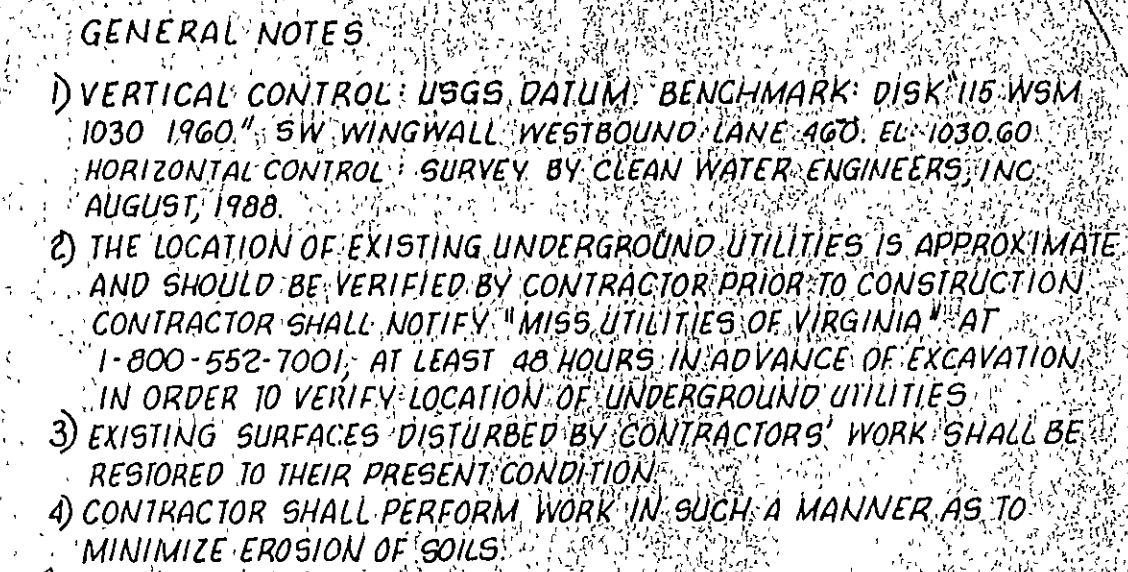
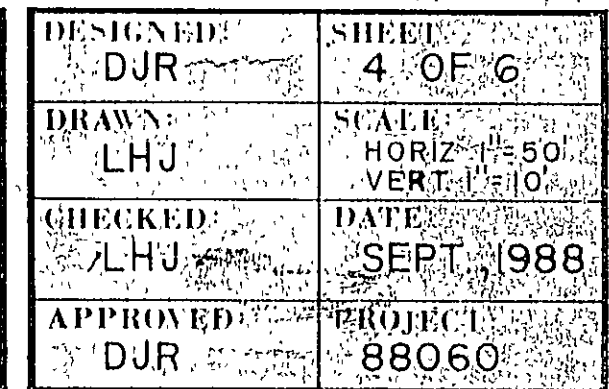
5. ADDED D.I.P. NOTE @ MH 17 - MH 19
 4. ADJUSTMENTS FOR CHANGE TO METERING
 CHAMBERS
 6. REV. PLAN & PROFILE MH19, 19A, 19B 2. ADDED: 3.5 PIPE - SDR 35 PVC
